## Product Change Notification / KSRA-15TQLX387

CCB 4633 Initial Notice: Qualification of MMT as a new assembly site for SST49LF008A device family available in 32L PLCC (11.5x14x3.37mm) package

**CCB 4633**  
**Pre and Post Change Summary**  
**PCN#:KSRA-15TQLX387**

# **QUALIFICATION PLAN SUMMARY**

# Lead frame comparison

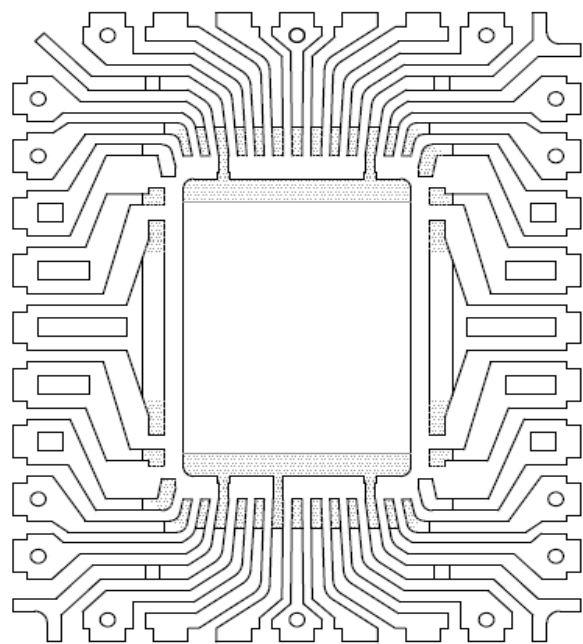
PAD SIZE:181x261 MILS  
FUSED LEAD ON PIN#16

Post Change

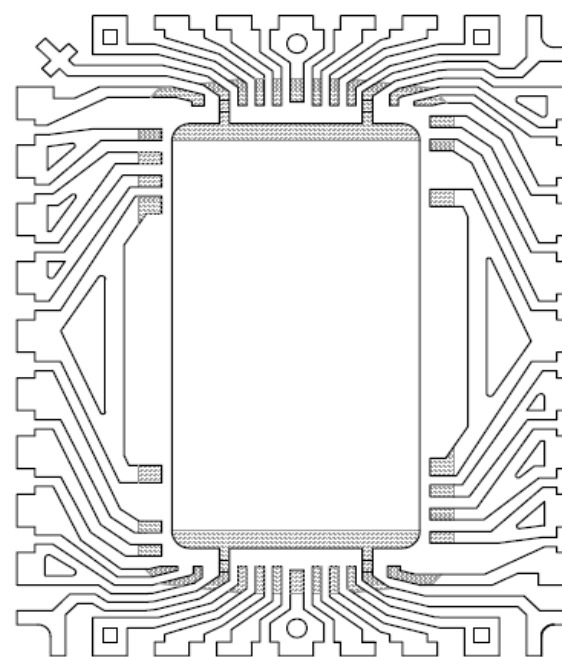
PAD SIZE:200x365 MILS  
NON-FUSED LEAD ON PIN#16
